Access Compliance Report

Public Rights-of-Way

| Intersection ID: 32296 | Main Street: BAILEYWICK_RD | Cross Street: LISHA_LN | Location: NW |
| ADA ID: D3B01685E2D9 | Ramp Type: PerpDiag | Initial Pass/Fail: Fail | Overall Compliance: No |

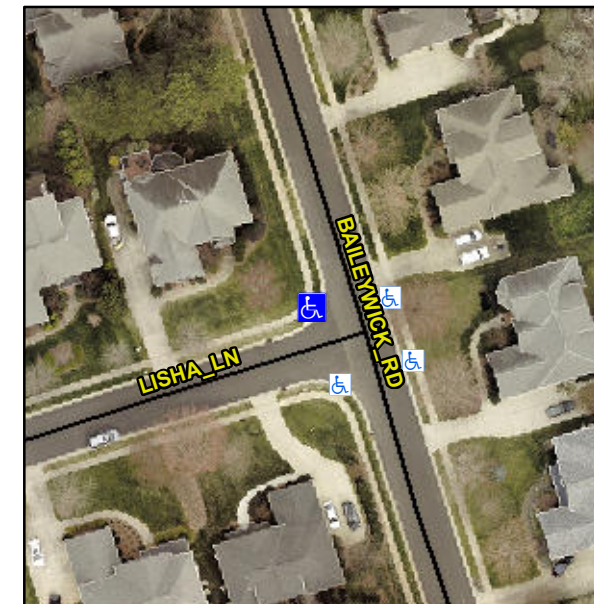
Not Found, R304.5.1, R304.5.3

| Compliance | Description | Data | Compliance | Description | Data |
|------------|-----------------------|------|------------|-----------------------------|------|
| N/A | Ramp Length (in) | 50.0 | Yes | Ramp Slope (%) | 6.8 |
| No | Ramp Width (in) | 47.5 | No | Ramp XSlope (%) | 6.3 |

Remove & Replace Curb Ramp With Two New Directional Ramps or Equivalent.
